MCPB
Item No. 6
Date: 07.29.2021

2710 Washington Avenue, Administrative Subdivision 620190130

Administrative Subdivision Plan No. 620190130

Figure 4: Proposed Lot Configuration
(Green shading represents proposed Category I Conservation Easement)

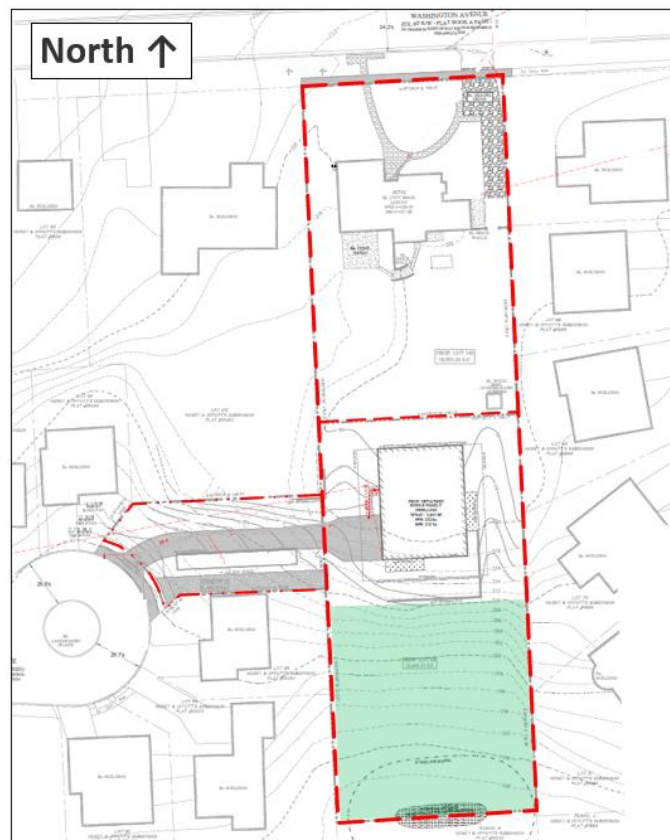
Previous submissions under this Application included a 3-lot proposal and subsequently a layout for a 2-lot scenario which placed the building envelope entirely within the environmentally sensitive areas. The initial proposals were not supported by Staff due to excessive environmental impacts and other concerns. Ultimately, the current layout (Figure 4) shifts the building envelope northwards into the flatter area with minimized impacts to the environmentally sensitive areas. The current layout includes an expanded Category I Forest Conservation Easement footprint which fully meets all the Forest Conservation worksheet requirements onsite through forest retention (with no afforestation/ reforestation or use of offsite bank, or payment of fee-in-lieu). Additionally, the southern side BRL was modified to maintain at least 15' separation between the BRL for the new home and the ultimate conservation easement footprint.

home, an expanded BRL, and Category I Conservation Easement, reduces the area of forest cleared from 0.31-acres as originally submitted, to 0.22-acres. This modified proposal also increases the easement area from 0.19-acres to approximately 0.28-acres which fully meets all Forest Conservation requirements onsite, as calculated by the Forest Conservation Worksheet. These efforts to minimize forest impact are in line with both the Master Plan and priorities of the Forest Conservation Law; the Master Plan states that “urban forestry concepts should be applied both inside and outside the parks to improve the quality of the urban ecosystem...to create pockets of native trees and understory vegetation within the urban ring to better support the remaining natural ecosystem.” While the Forest Conservation Regulations identifies the following features as priorities for retention: *Trees and shrubs in sensitive areas (such as steep slopes and near wetland buffers); areas of contiguous forest and forest identified as high priority for retention; individual specimen trees.*

Exhibit A: *Fire Access Plan, prepared by O'C&L, dated July 13, 2021*
Exhibit B: *Plat of Subdivision #15020, as recorded in the Land Records of Montgomery County, MD (Mark-ups by O'C&L)*

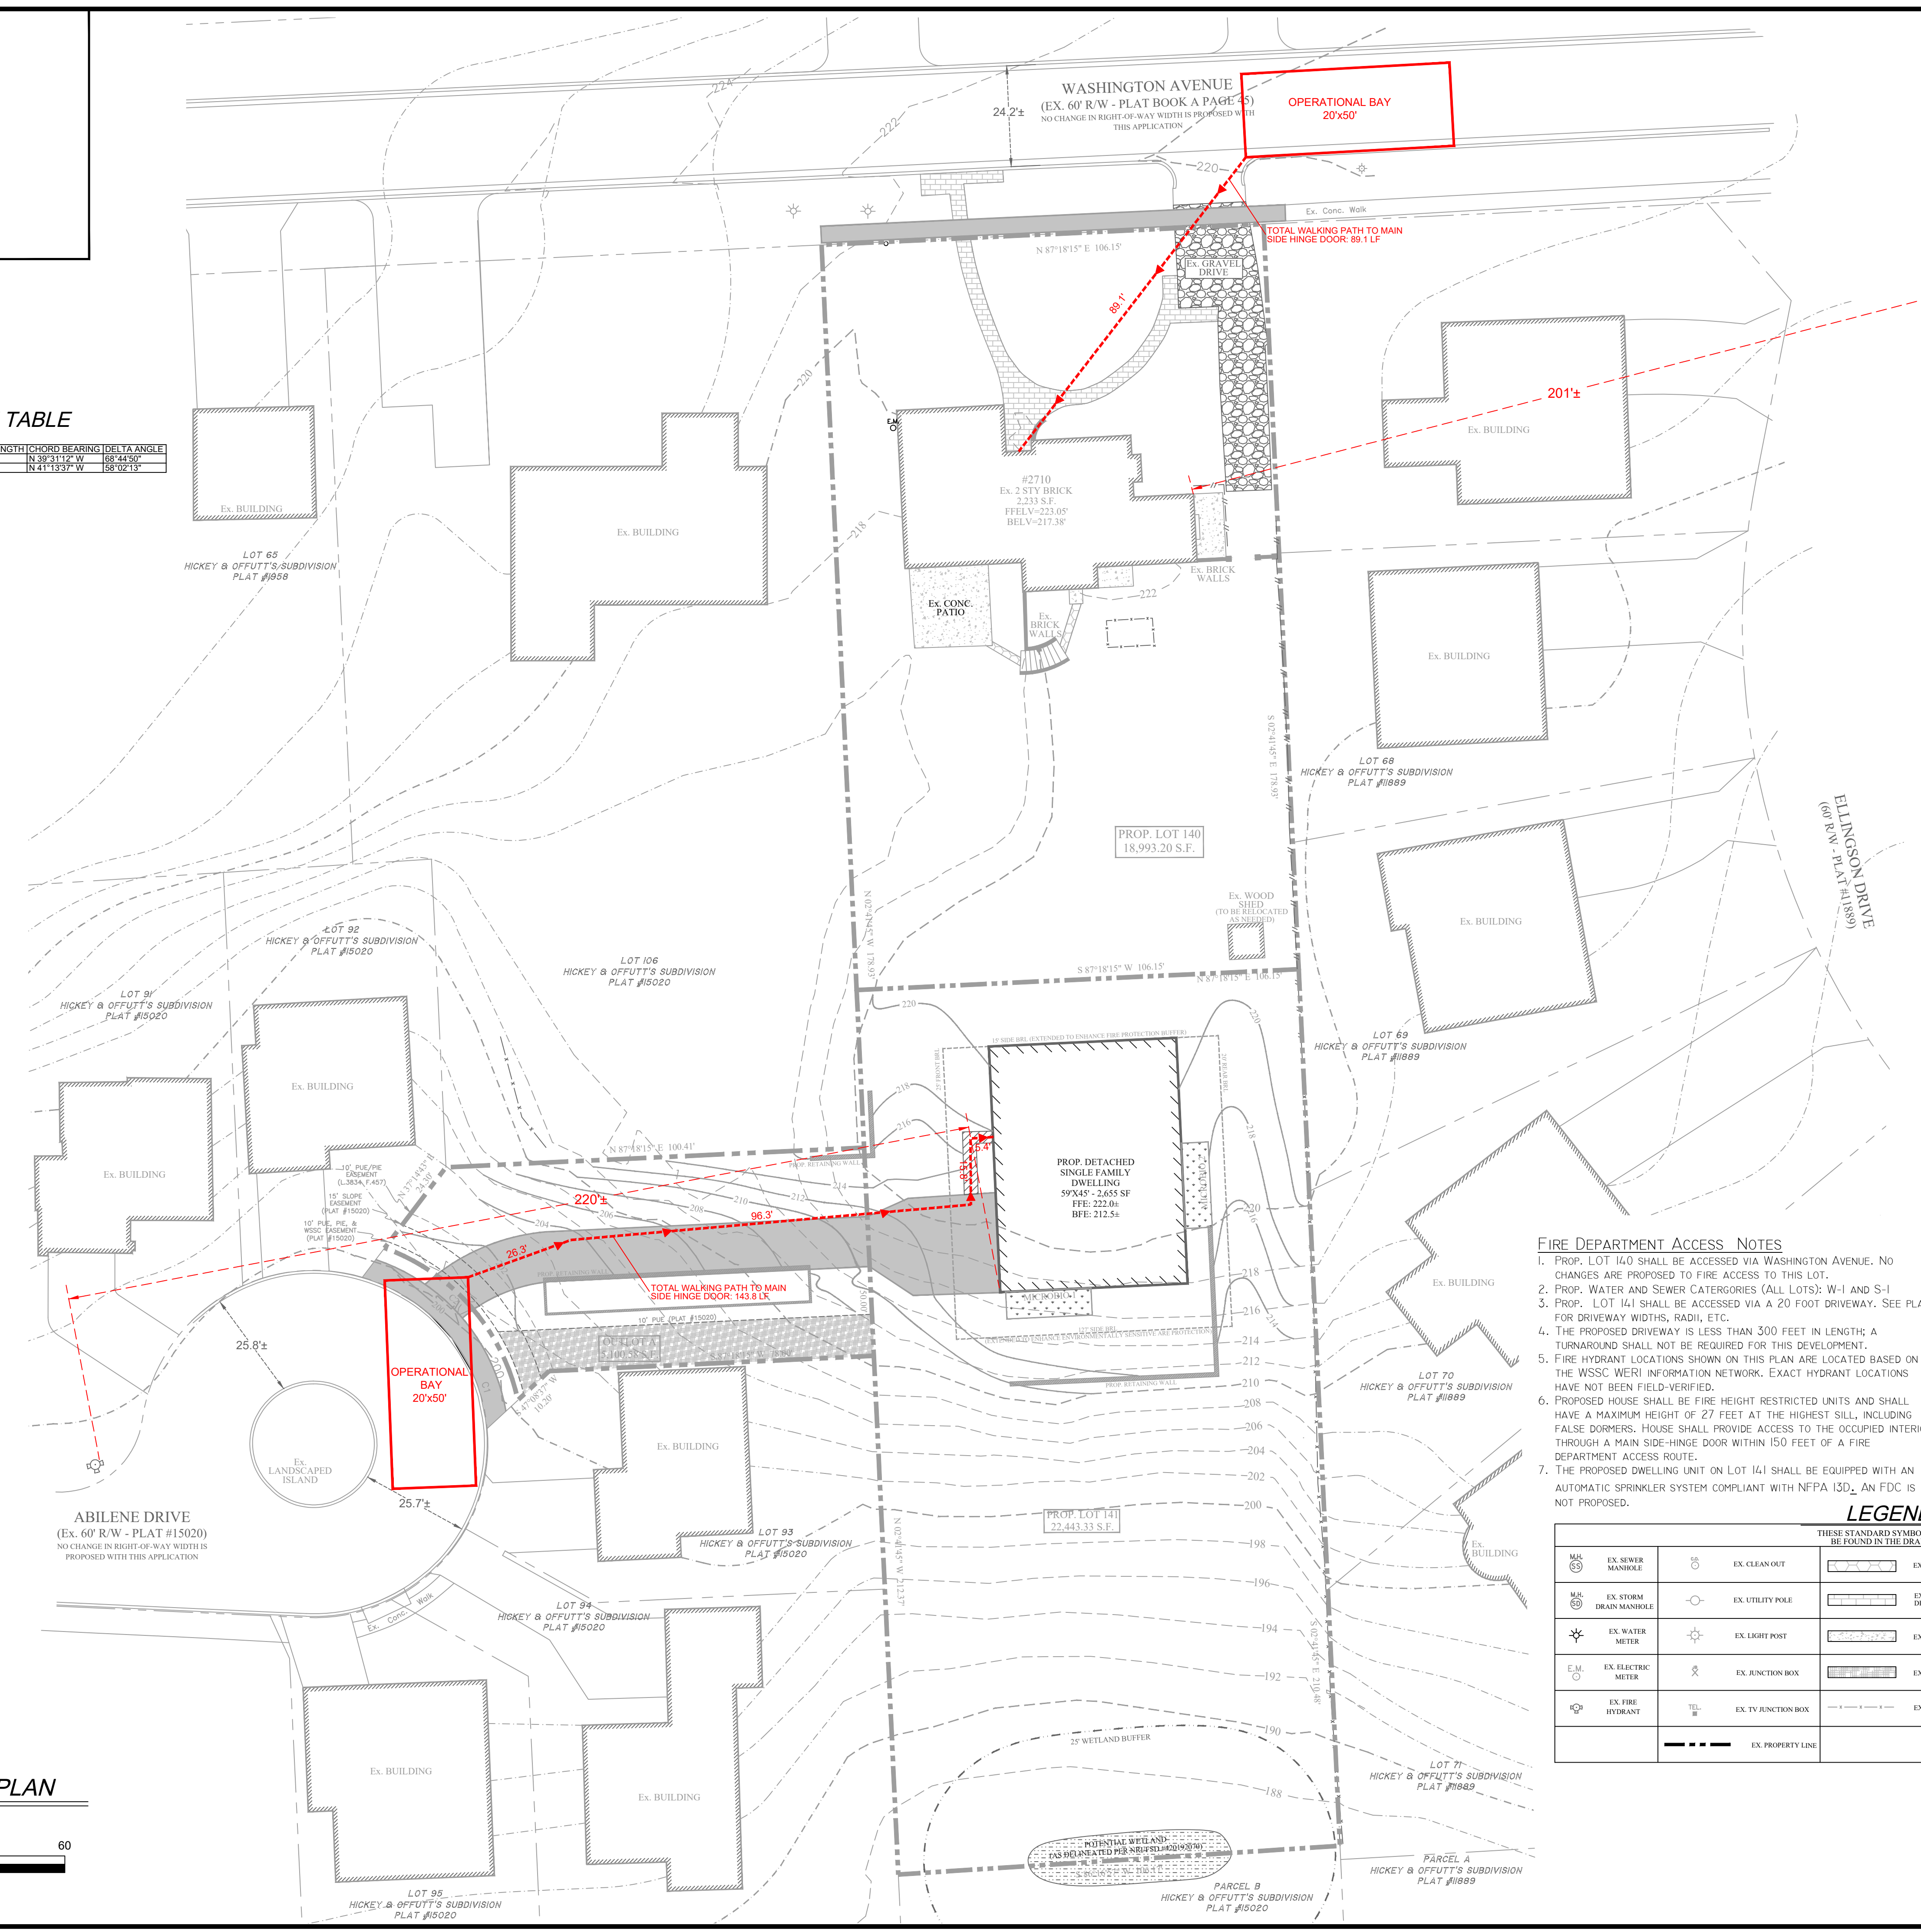
1. Fire Department vehicular access dead ends shall be no more than 150 feet long before providing a compliant turnaround. Abilene Drive cul-de-sac must be at least 90ft to qualify.
5. Show that [*sic*] Abilene Drive is a compliant fire department vehicular access path.

1. Showed an approximate location of the Operational Bay on the Fire Access Plan.
2. Determined the overall length of walking path to reach the main side-hinge door. Note that O’C&L has shown these locations for both houses.

A Fire Department Access plan has been prepared for the proposed development and is attached to this letter as **Exhibit A**. As designed, existing Lot 46 shall be divided into two (2) separate lots. The first proposed record lot has frontage on Washington Avenue and is developed with an existing house; this house is proposed to remain. The second proposed lot is primarily in question and is proposed to be accessed from Abilene Drive through existing Outlot A, as shown on Exhibit A. Note that the overall layout of the proposed subdivision has been revised from the version of this Statement of Performance Based Design as previously submitted to you in November, 25, 2020 and as a result of design correspondence with M-NCPPC Staff. It is O’C&L’s understanding that the layout as found on this Fire Access plan mirrors M-NCPPC Staff’s preferred layout for the subdivision, and is in substantial conformance with the layout that will be recommended by Staff to the Planning Board at the scheduled hearing to be held on July 29, 2021, although certain exact parameters, such as the exact amount of Forest Conservation Area proposed on Lot 141, shall be addressed by M-NCPPC Staff with conditions of approval on the document to be brought before the Planning Board.

Based on these conditions and the explanation as found herein, it is the belief of O’C&L that suitable emergency services access is provided, and, on behalf of the Applicant, we formally request this statement of performance based design justification be accepted and approved by the Montgomery County Department of Permitting Services/Fire and Rescue Services - Fire Prevention and Code Compliance Section in conjunction with the listed Administrative Subdivision application.
